402<sup>ND</sup> BATTALION IRAQI ARMY  
HEADQUARTERS BARRACKS  
AL HILLAH, IRAQ

**SIGIR PA-06-077**  
**JANUARY 29, 2007**

SUBJECT: Report on Project Assessment of the 402nd Battalion Iraqi Army Headquarters  
Barracks, Al Hillah, Iraq (Report Number SIGIR-PA-06-077)

**Site Photo 1. Barracks entrance door cross section**

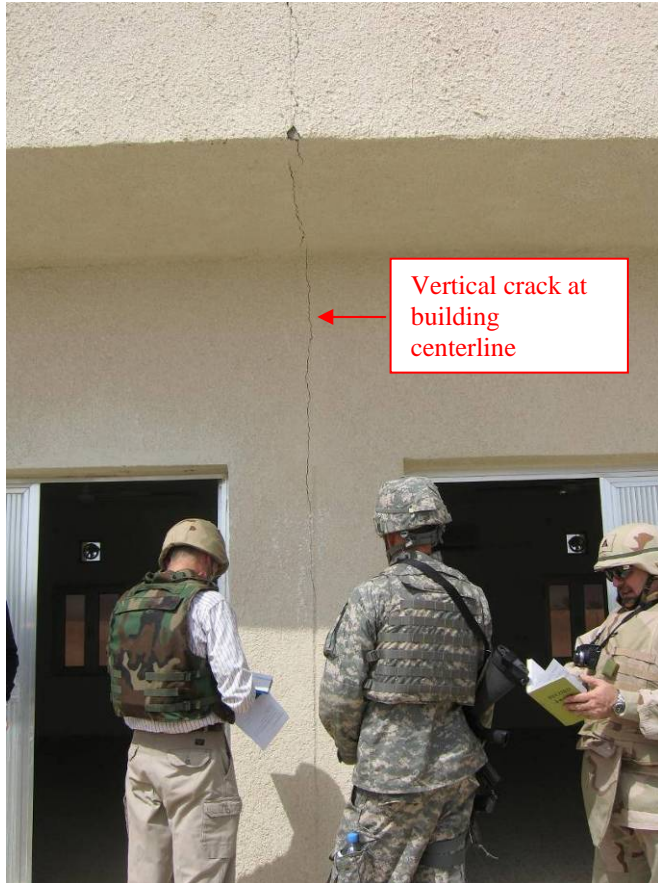
Although the interior appeared satisfactory, the two entry/exit aluminum doors in the barracks sleeping quarters did not appear to be "good quality," especially for the high traffic expected with a 75-man barracks. Site Photos 1 and 2 provide closer views of one of the aluminum doors and associated hardware. In addition, the doors did not have sweeps. Noticeable gaps were present between the thresholds and bottom of the doors as seen in the door shown in Site Photo 3.

**Site Photo 5. Vertical crack in front side of classroom building exterior**

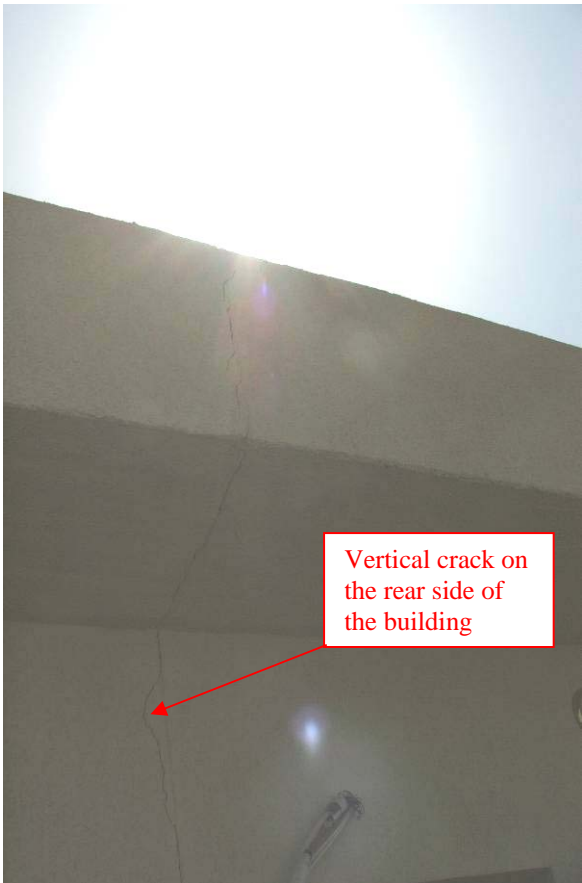
The design included two, two-ton HVAC units in each classroom augmented with a ceiling fan, and two wall exhaust fans, which we verified as installed. Overall, the building appeared satisfactory, except we did observe a noticeable crack in the exterior near the center of the building. The crack ran on both sides of the building, beginning at the sidewalk and continuing vertically in the wall and along the soffit and parapet as shown in Site Photos 5 and 6. The structural design for the building shows in the center of the building, a 480 mm masonry wall consisting of two, side by side masonry wall sections, each 240 mm thick. The design also shows the dual masonry walls supporting two adjoining bond beams, each 250mm thick. The design does not show any tying mechanism between the dual masonry walls or connecting reinforcing steel or dowels in the two concrete beams. Based on this design and the presence of the vertical crack along the building centerline, it appears there should be an expansion joint in the center of the building to allow for the differential movement of each side of the building.

Vertical crack at building centerline

**Figure 1. Design detail for covered parking (sunshade)**

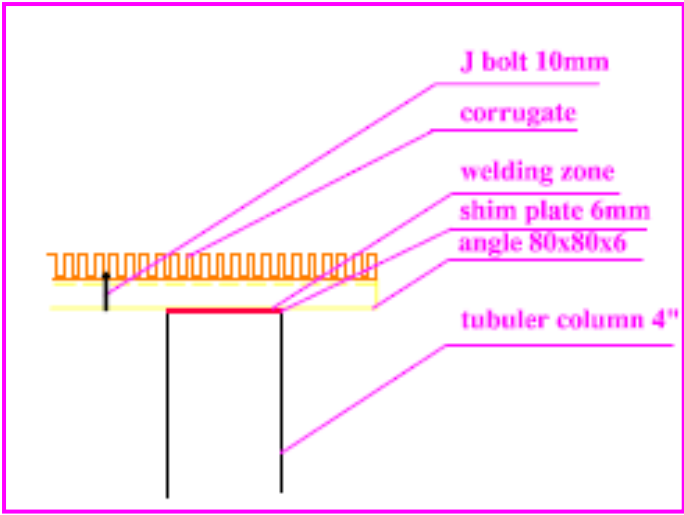
The design detail for the structural frame supporting the corrugated roof sheeting (Figure 1) showed an 80 x 80 x 6 angle supporting the roof sheeting. No units were provided for

the angle, although it is assumed the dimensions are in millimeters. Figure 1 also shows the angle welded to a shim plate at the top of the column. There were no details provided on the type or size of weld or the type and thickness of the corrugated roof sheeting. The design also did not show any lateral cross bracing perpendicular to the angle support shown in Figure 1.

**Site Photo 13. Typical column support for covered parking (sunshade)**

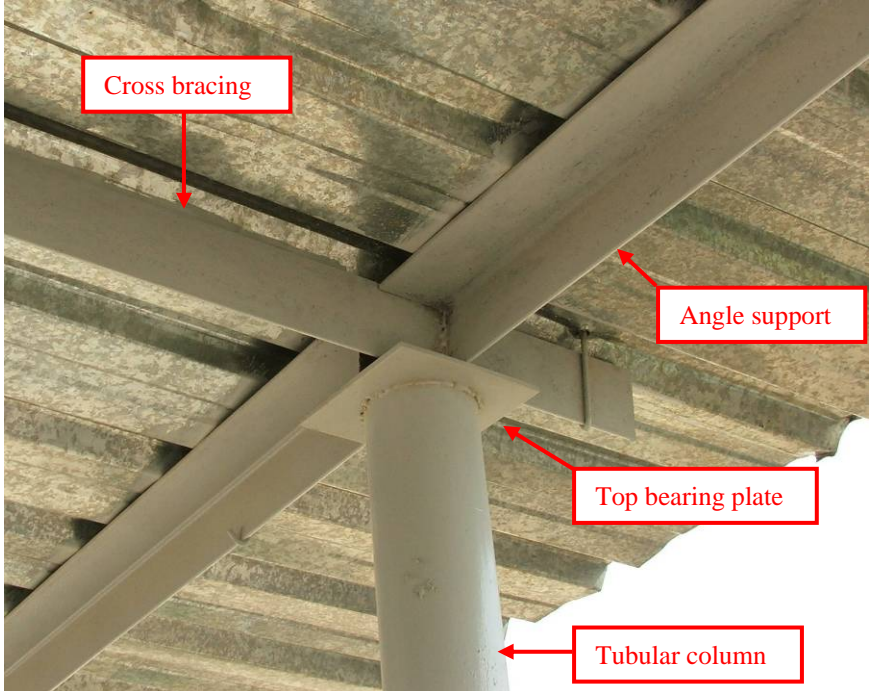
Site Photo 13 shows the actual welded angle connections at the bearing plate (i.e., shim plate) at the top of each tubular column. Also shown is the lateral cross bracing. The roof sheeting material appeared to be a thin gage sheet metal, connected to the frame with J-bolts as depicted in Figure 1.
